SUBJECT: Responses to Request for Additional Information Related to the TRUPACT-III
Application for Exemption.

Docket No. 71-9305, Model No. TRUPACT-III Package

**Corrected Response to NRC Request for Additional Information No. 1,
Dated June 24, 2015**

TRAGIS Route Comparison Figure:

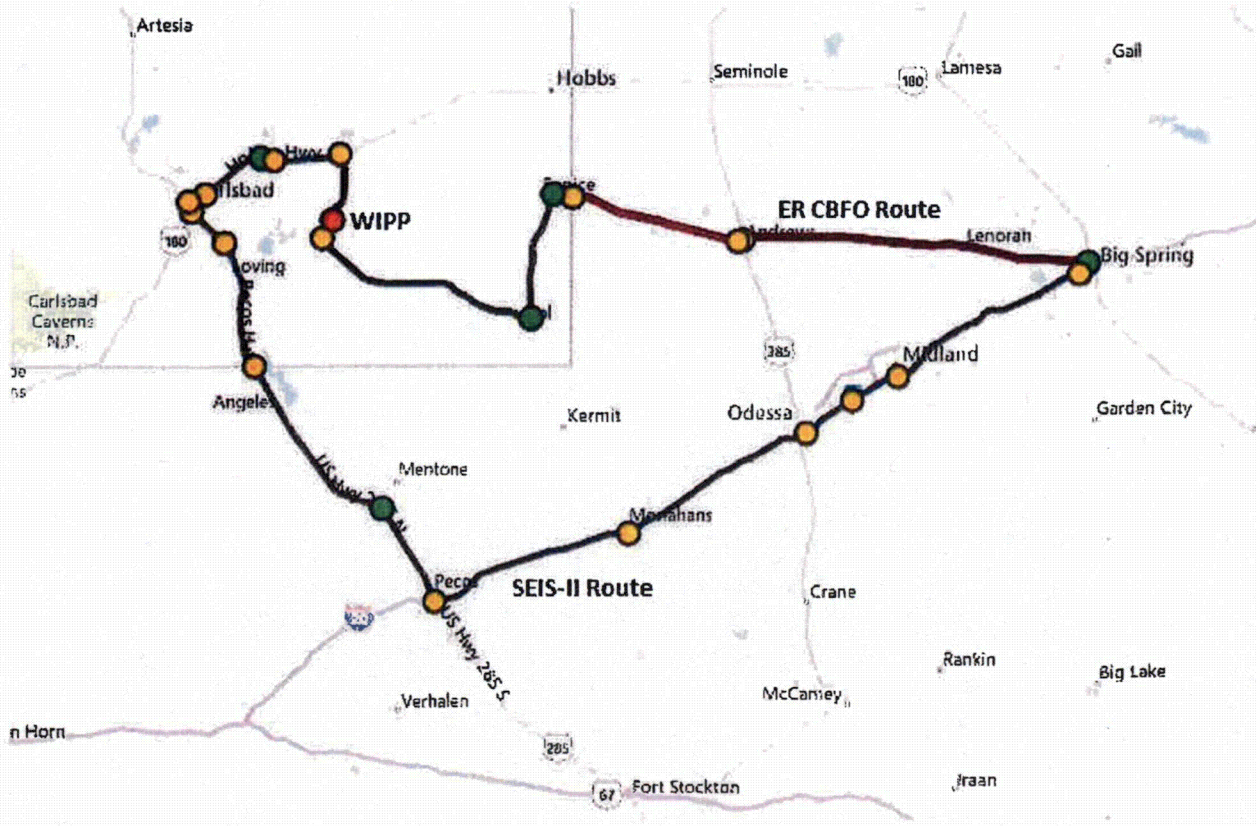
The transportation route listed on page 20 of the environmental report (ER) is slightly different than the route used in the Waste Isolation Pilot Plant Disposal Phase Final Supplemental Environmental Impact Statement (SEIS-II). The route differences begin in Texas. Show how the route provided in the ER is bounded by the route used in SEIS-II (e.g., number of miles, rural vs suburban area, etc.).

As commented, the current ER CBFO route deviates from the SEIS-II route beginning in Big Spring, Texas where a more direct route through Andrews, Texas runs to the south WIPP access road in New Mexico. TRAGIS was used to compare the node to node characteristics between the differing routes (see tabular results and figure illustration below). Starting at the Big Spring, Texas junction, the mileage in Texas and New Mexico following the current CBFO route is approximately 160 miles. Respectively, the total mileage in Texas and New Mexico following the SEIS-II route (SEIS-II, Appendix E, page E-10) is approximately 257 miles. In addition, the distance travelled through populated areas has decreased. This is due to removing the more populated cities of Midland and Odessa, Texas and Carlsbad, New Mexico from the SEIS-II route in preference to Andrews, Texas, and Eunice and Jal, New Mexico. This effectively reduces the population along route areas.

For this route comparison and given that the impacts from transportation are driven by distance and associated population density, the current route listed on page 20 of the ER is bounded by the SEIS-II.
